**STATE OF CALIFORNIA
State Energy Resources
And Development Commission**

Subject: First Solar's Topaz Solar Farm Revised Project Footprint

Docket No. 07-AFC-8

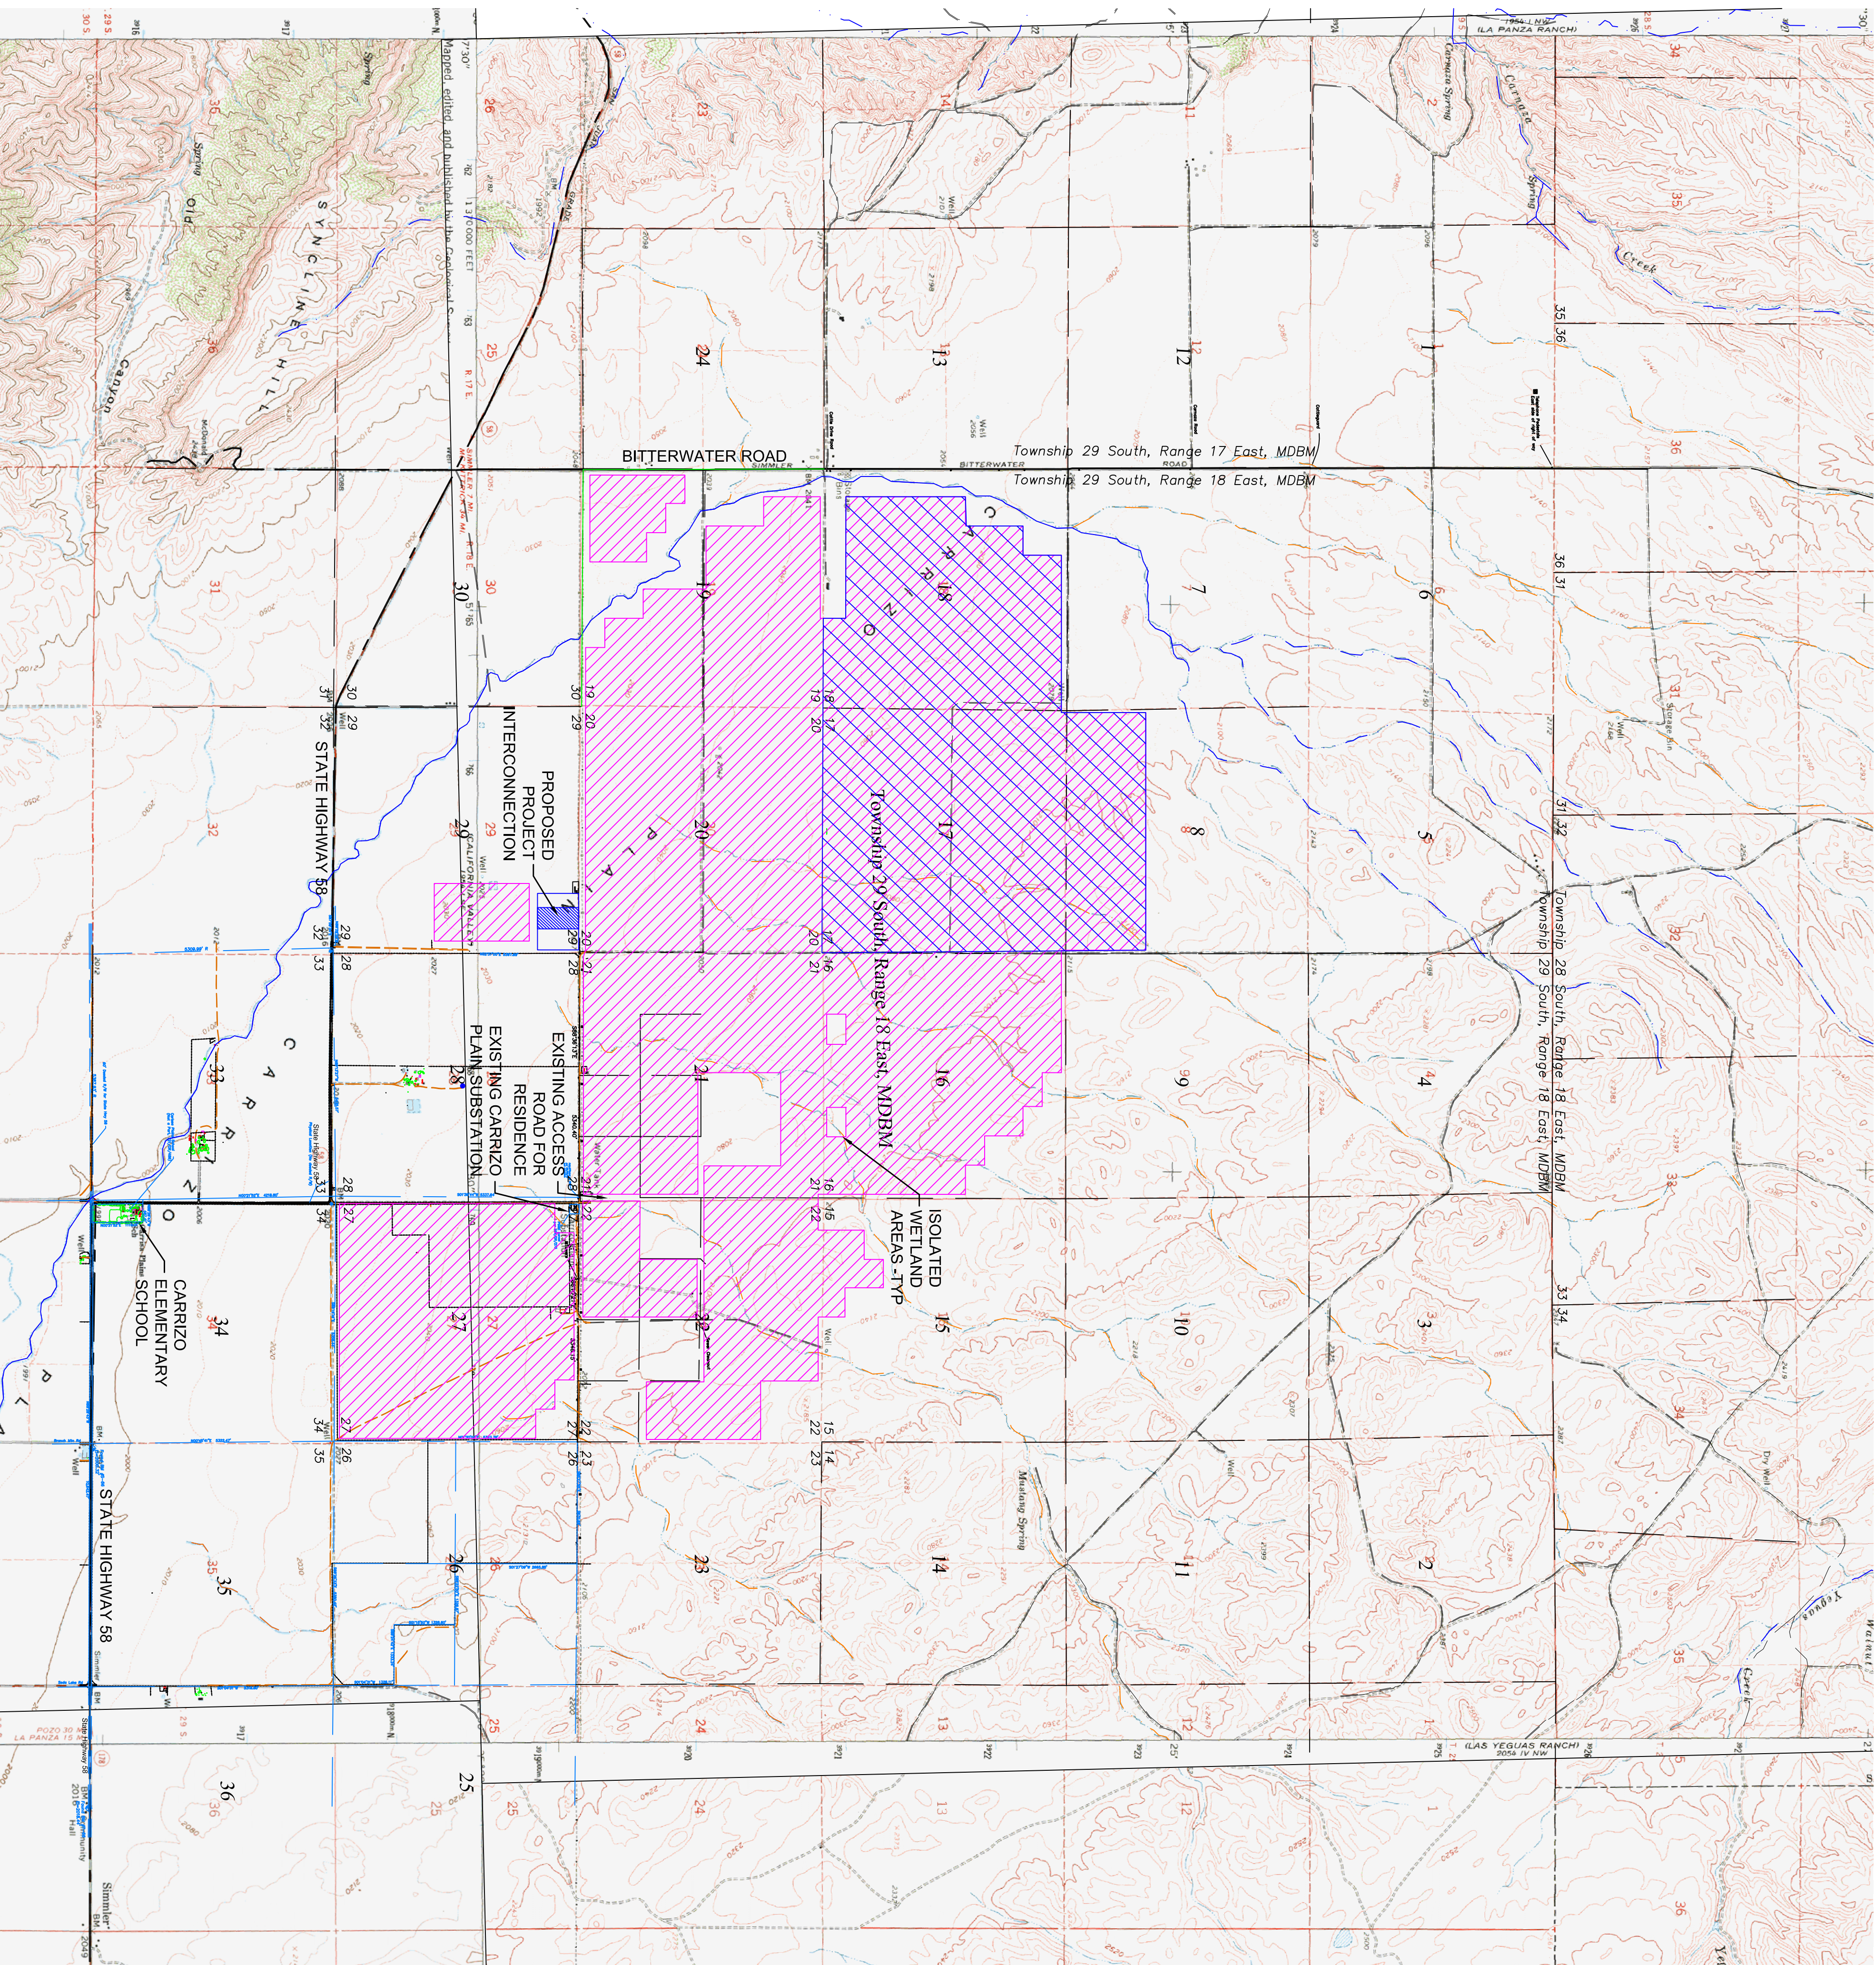
On May 27th I received First Solar's Revised Project Footprint, as you can see First Solar completely blocks the Wildlife Corridor to the north. First Solar plans on completely surrounding local residents and also almost completely surrounding the Carrizo Energy site. First Solar has not supplied their current noise, water and traffic assessments and are currently using OptiSolar's obsolete information. All these issues directly affect the Carrizo Energy Project. I am requesting that the CEC acquire all current and up to date info on First Solar from San Luis Obispo County and or First Solar so cumulative issues can be addressed. I am also requesting that SC Wildlands include First Solar's revised footprint into their Corridor Model. We find it an extreme lack of good faith that First Solar has not readily provided accurate information for the Corridor Model.
